Re: 1900 Lasuen Road, El Encanto Hotel

Subject: Draft Mitigated Negative Declaration  
Public Comment

**Exhibit M**  
TJMltr15jan2009

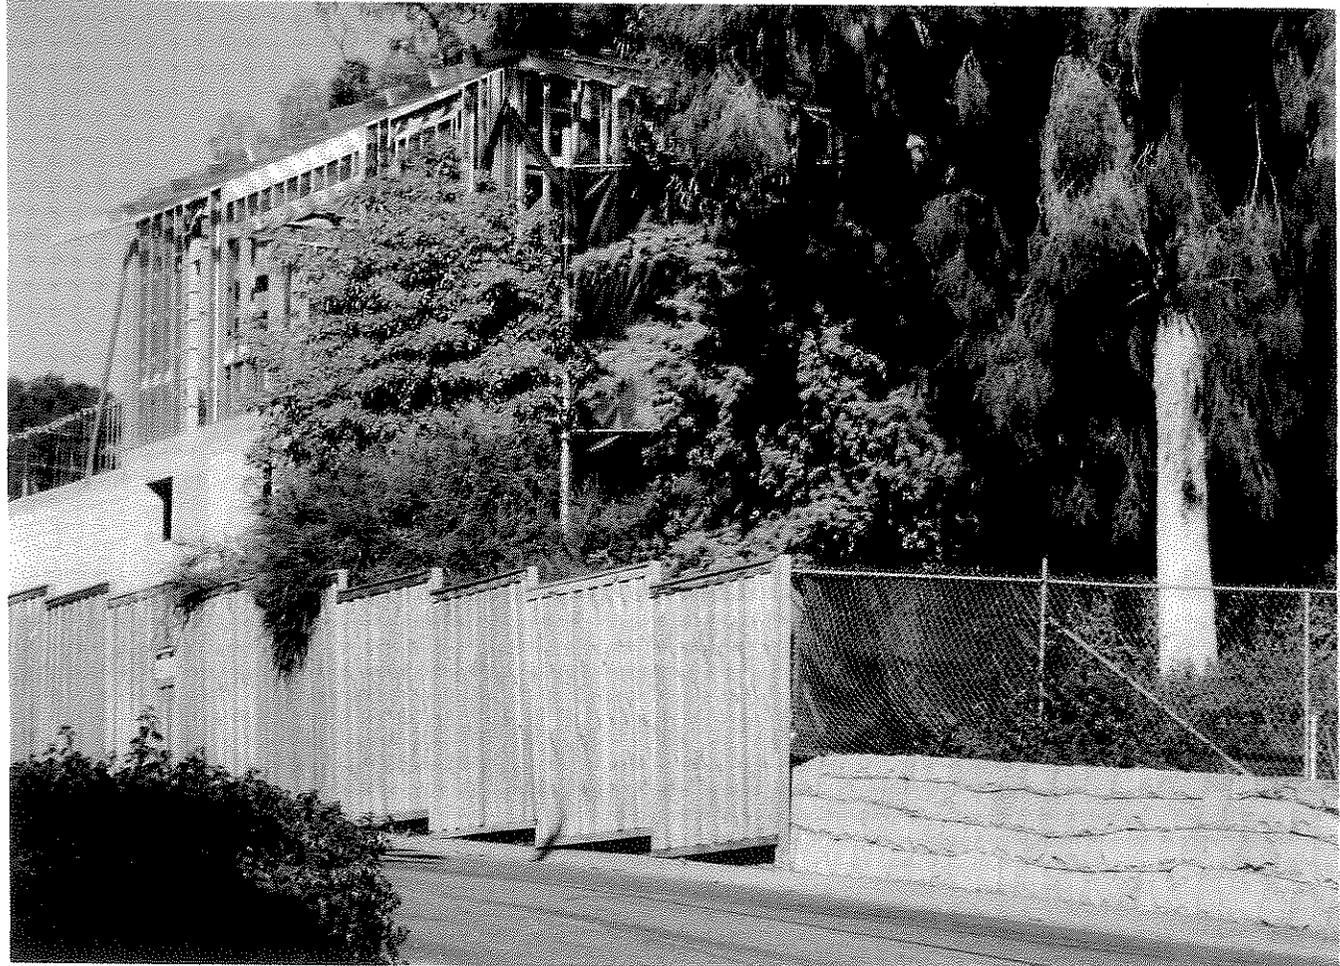
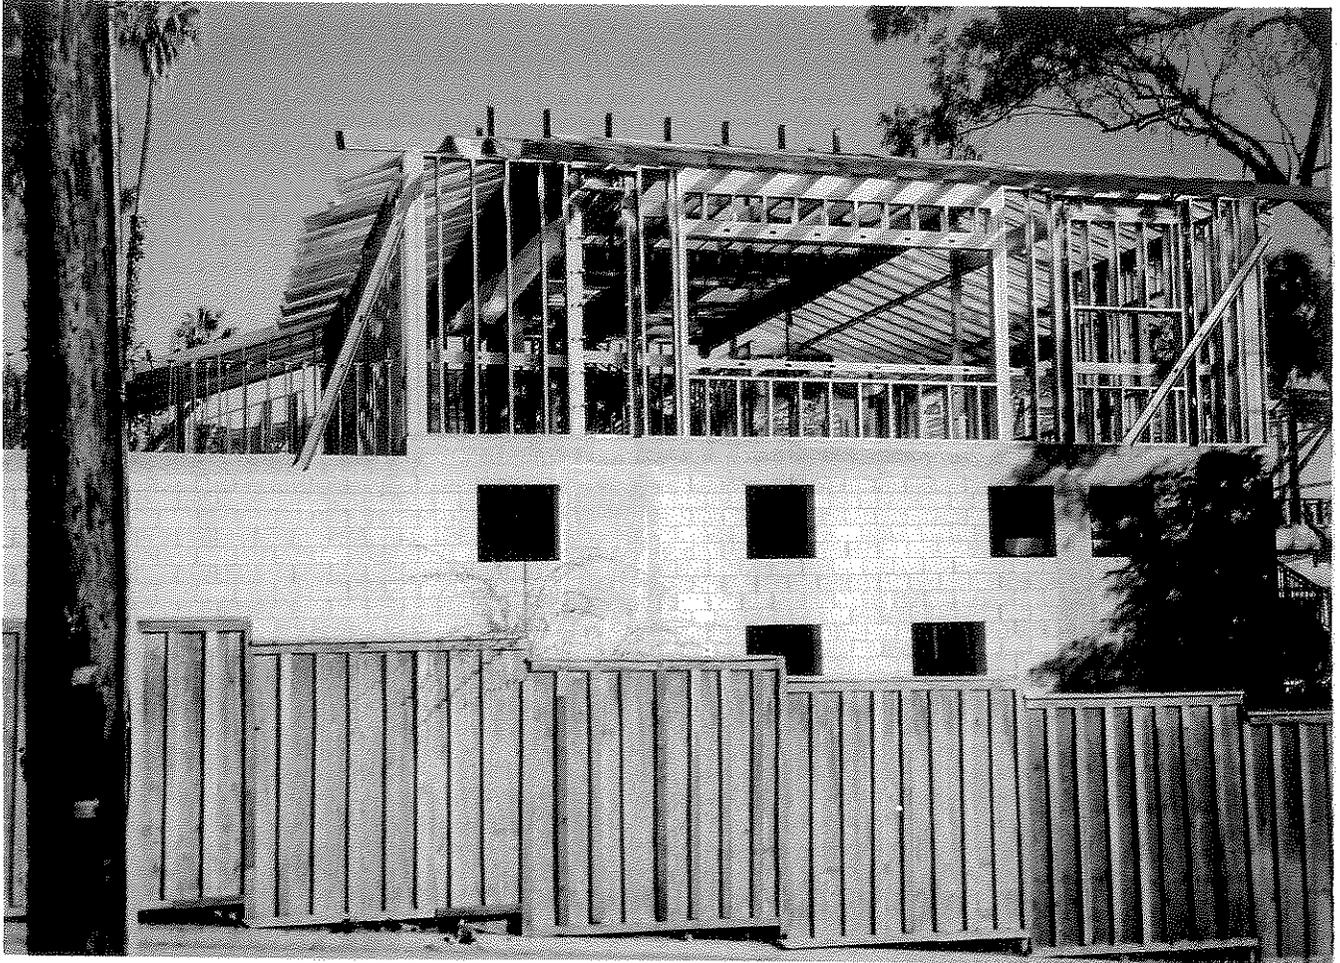
Our clients, the Leslies at 1970 Mission Ridge Road, have a wonderful view of the Channel Islands and the El Encanto. Much to their surprise, their view of the City and specifically the tower spire of the Arlington Theatre are going to be blocked by the new construction of the main building. A panoramic color photograph (Exhibit L) shows the structural steel frame now being erected at the main building. A close-up of this photograph (Exhibit M) shows the Arlington spire in the middle of this framework. This spire was clearly visible to my clients when they bought their house in 2004. This is not a two (2) foot increase in height but more like eight (8) to ten (10) feet or perhaps even more! How did this happen?

**Exhibit N**

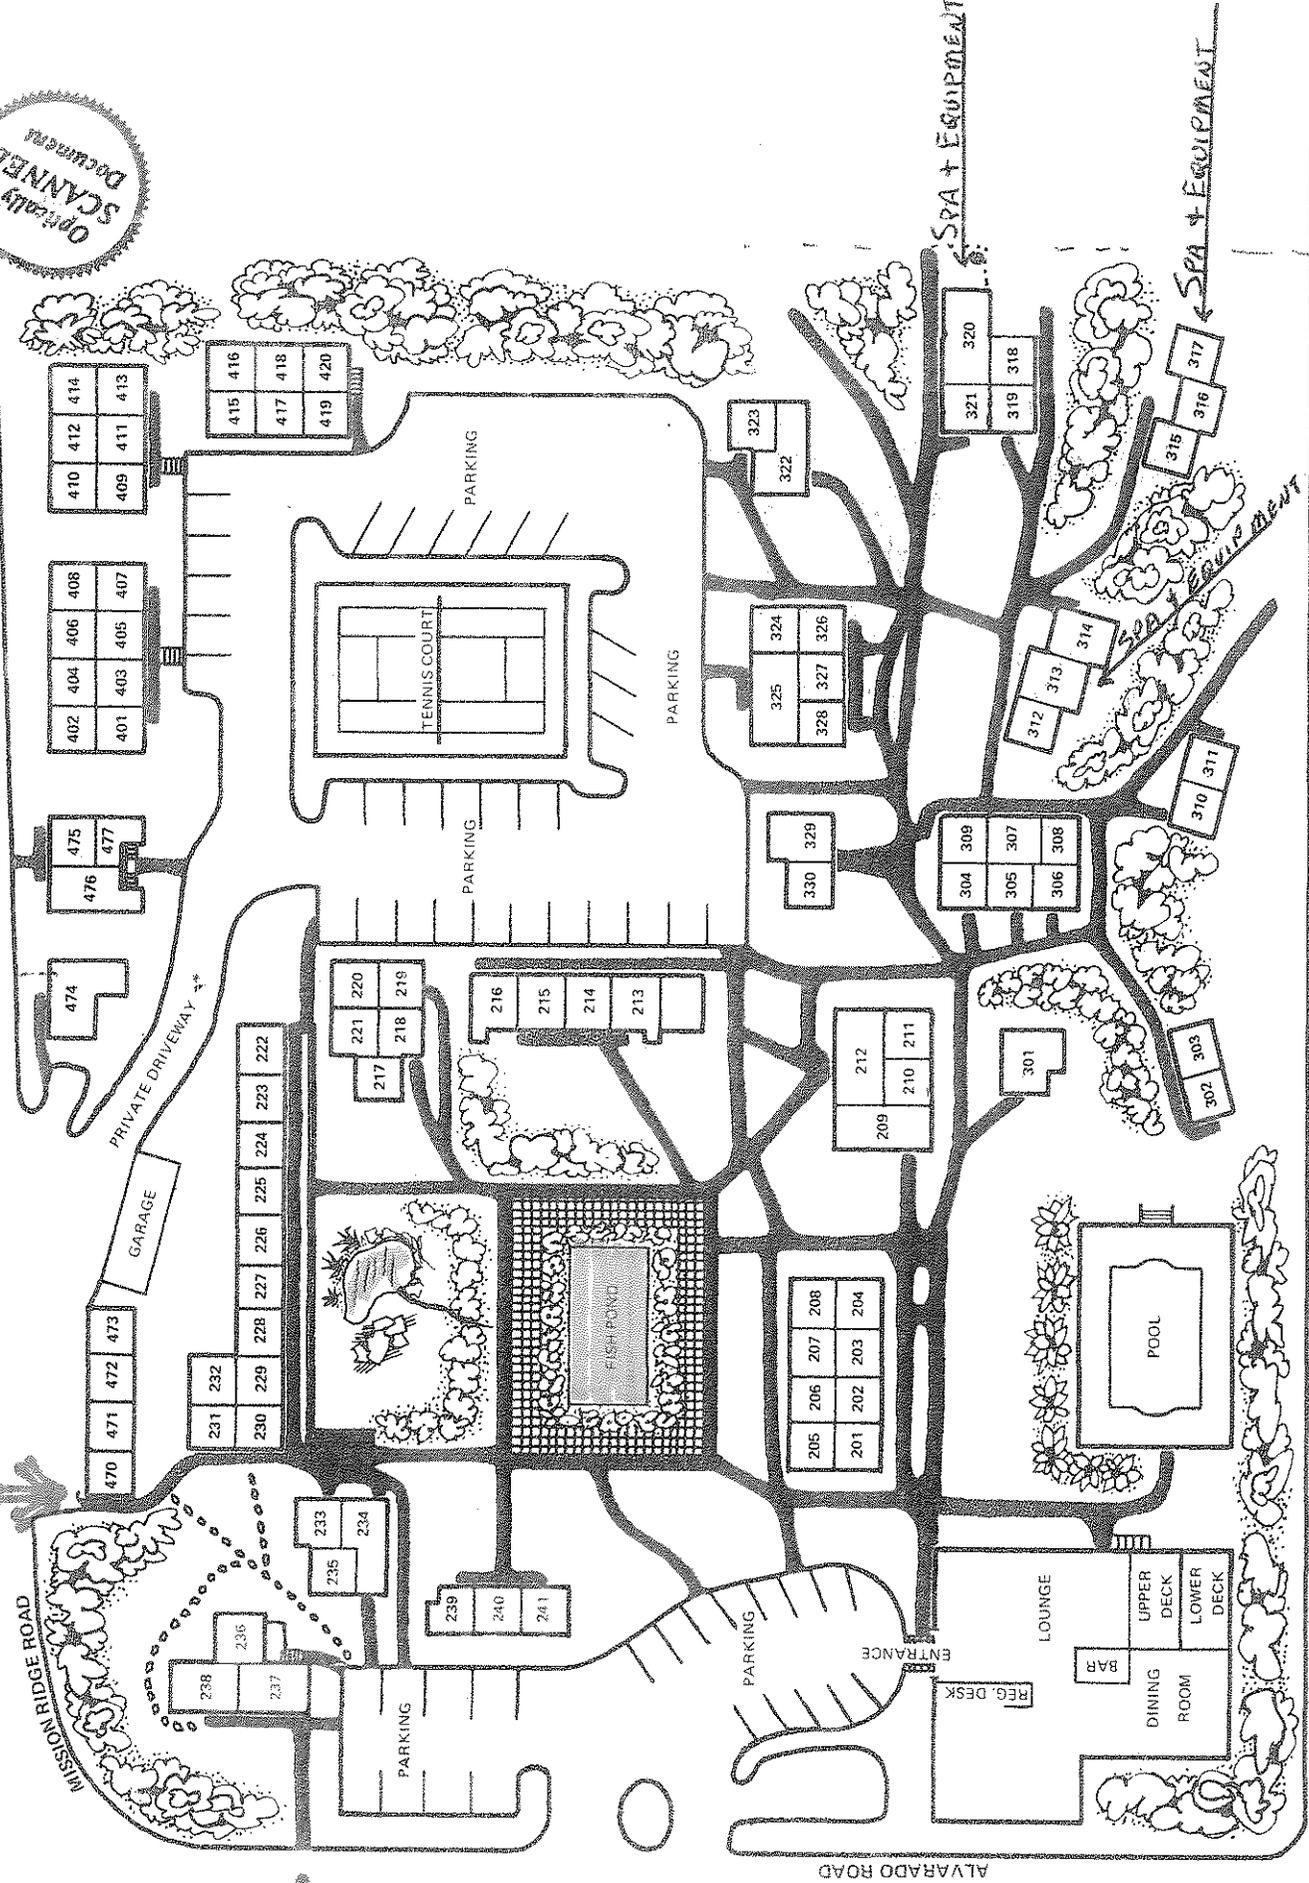
The noted suspicions mentioned above are also based on the City Archival photographs 31 and 32 of the west elevation of the main building (Exhibits N) and (Exhibit O) note the stonewall in Exhibit N is about four (4) feet high. Now compare this photograph with ones taken just this week (Exhibit O). Note the wood framed construction fence is eight (8) feet high and this elevation clearly shows the new building much higher than the original taken before demolition of the existing main building.
